PLANT NAME: Oconee Units 1-2-3

Response to NRC request for additional  
info. concerning the fire protection  
program.....w/att set of drawings...

Reference: Oconee Nuclear Station  
Docket Nos. 50-269, -270, -287

RESPONSE TO  
REQUESTS FOR ADDITIONAL INFORMATION  
OCONEE UNITS 1, 2, AND 3  
FIRE PROTECTION

0-302A

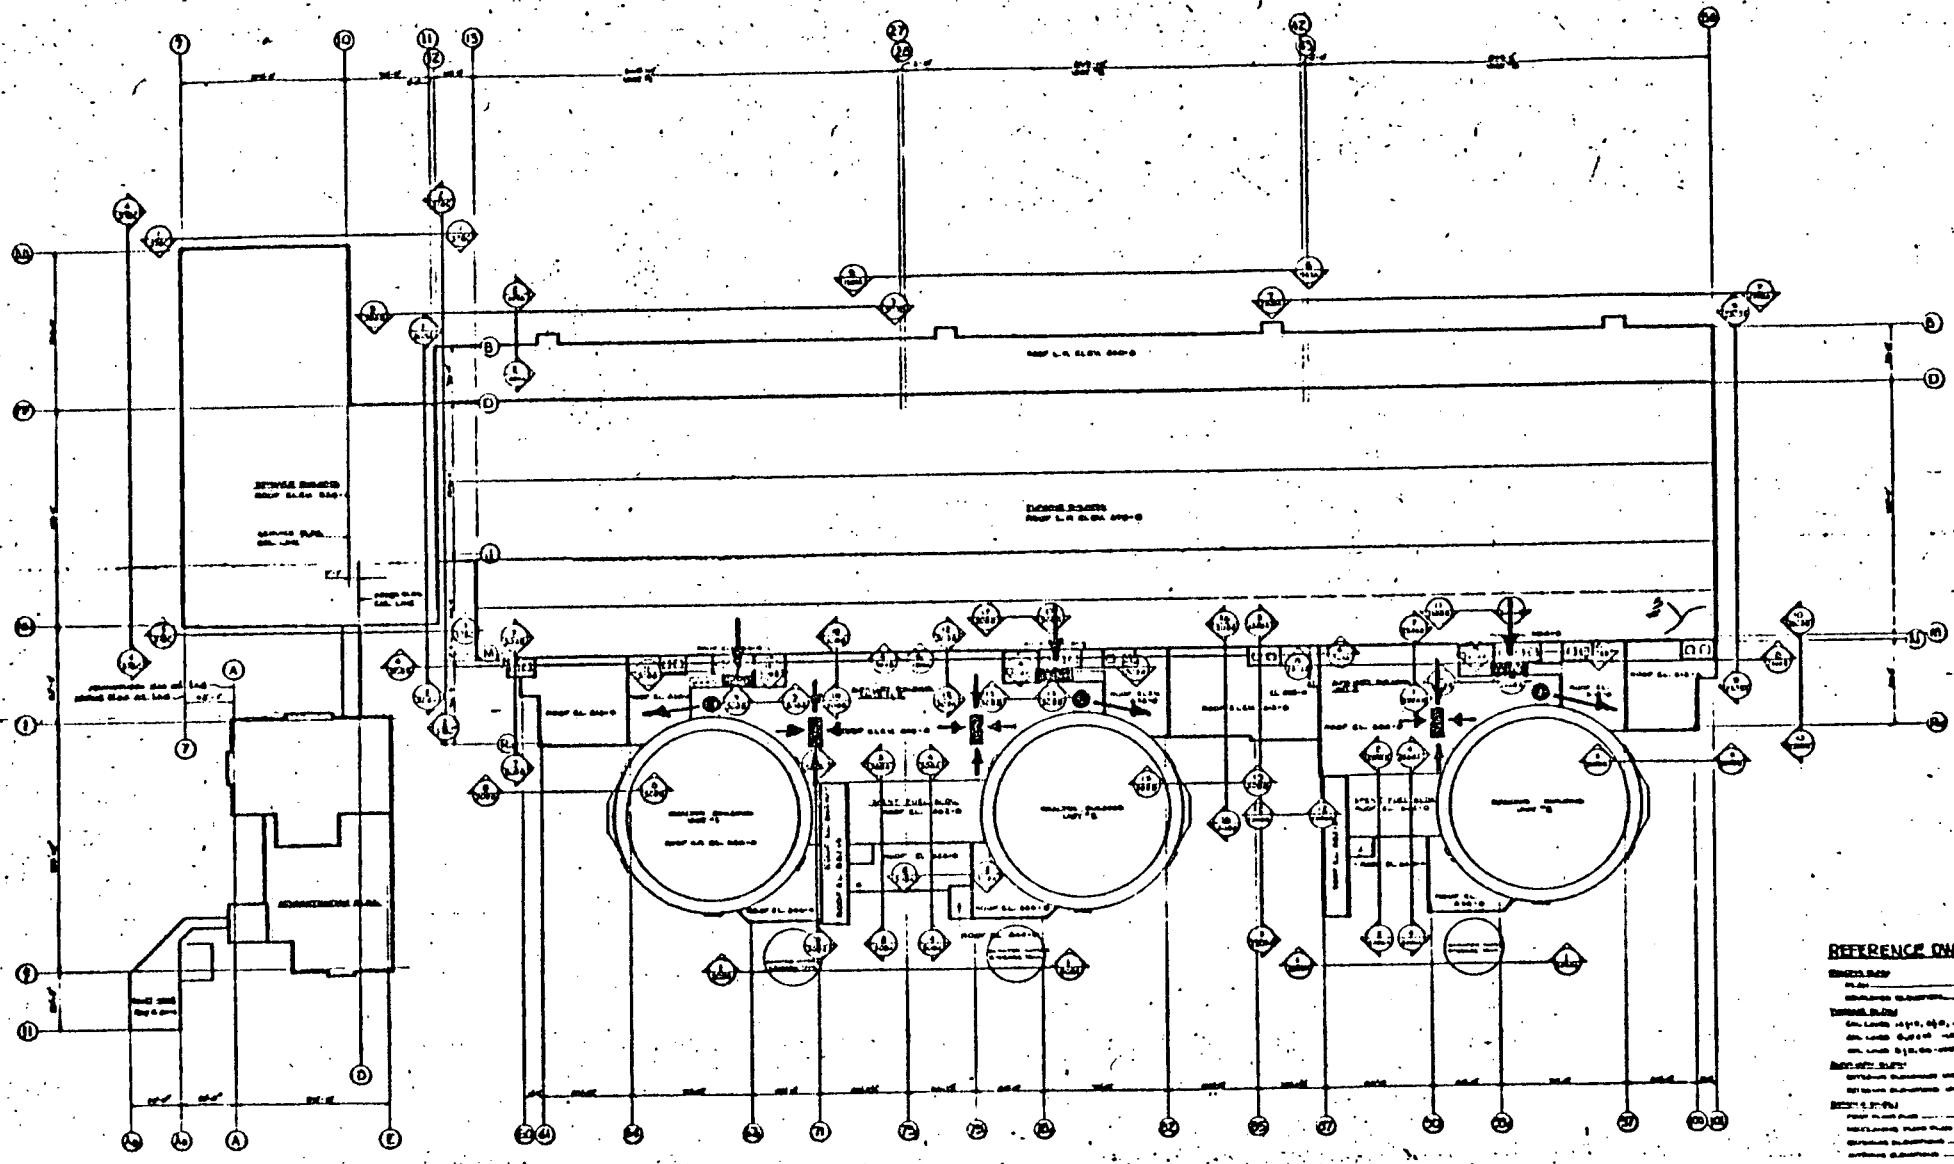
Identify the location of ventilation air intake and exhaust openings and describe the potential for smoke being drawn into air intakes after being exhausted from another area.

The closest ventilation air intake is approximately 12 feet horizontally and 145 feet vertically from the unit vent. All exhaust from the Auxiliary Building is routed to the unit vent. Any products of combustion from a fire would be well diluted by exhaust taken from other areas of the Auxiliary Building prior to reaching the unit vent. The exit velocity from the unit vent is approximately 3900 fpm which would tend to make it unlikely that smoke would be drawn into the intake. Thus the separation and exit velocity combine to minimize the occurrence of such an event. The proximity of turbine building exhaust to the nearest Auxiliary Building air intake is approximately 12 feet horizontally and 7 feet vertically. The turbine exhaust is above this intake and fans of the upblast type are utilized. The fan exit velocity is approximately 2400 fpm, therefore, the location and the exit velocity would tend to preclude the potential for combustion products being drawn into the Auxiliary Building intake. See attachment No. 1 for the auxiliary intake and exhaust arrangement.
